SB Number:	SB PF-016	Creation Date: 04/02/2009
Subject:	Paper conveying failure may occur	
Model:	PF-750

Affected models: KM-3050/4050/5050, KM-C2520/3225/3232/2525E/3232E/4035E

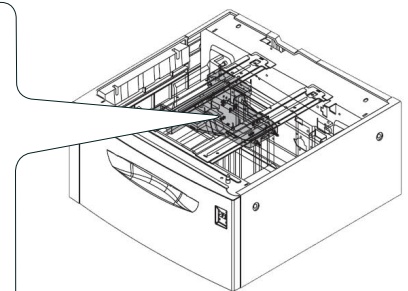
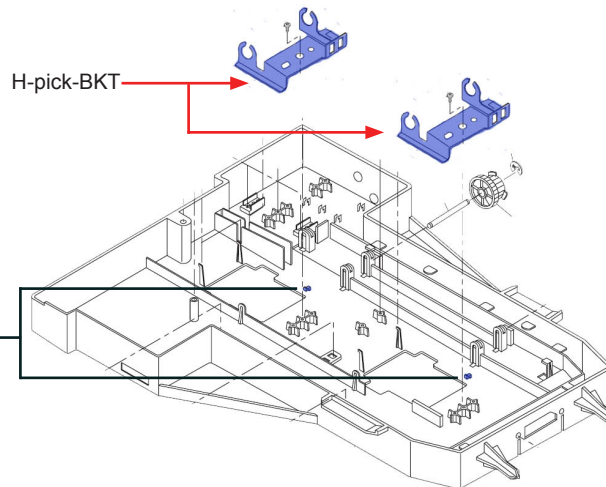
Phenomenon	Paper conveying failure may occur.
-------------------	------------------------------------

Close up of the hooks for the H-pick-BKT

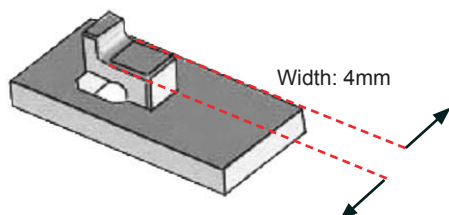
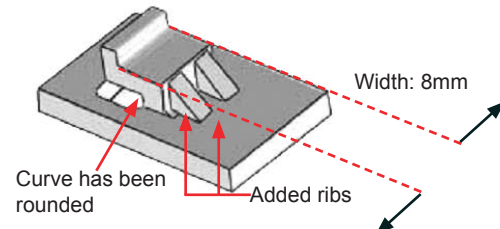
Cause	The hooks for the H-pick-BKT at the H-conveying base brake off, so that the H-pick-BKT 305A707361 loosens.
--------------	--

Phenomenon; Hooks of the H-pick-BKT at the H-conveying base brake off, so that the H-pick-BKT loosens.

Solution	<p>The following changes have been made to the hook at the H-conveying base:</p> <ol style="list-style-type: none"> 1. The width has been changed from 4mm to 8mm. 2. 2 ribs have been added. 3. The curve of the hook shape has been rounded.
-----------------	---

Classification	<input type="checkbox"/> Entire stock rework	<input type="checkbox"/> In-field modification at next visit	<input checked="" type="checkbox"/> In-field modification by case	<input type="checkbox"/> No modification necessary
Field measure	When the above mentioned phenomenon occurs, please install ASY-X (305H080620).
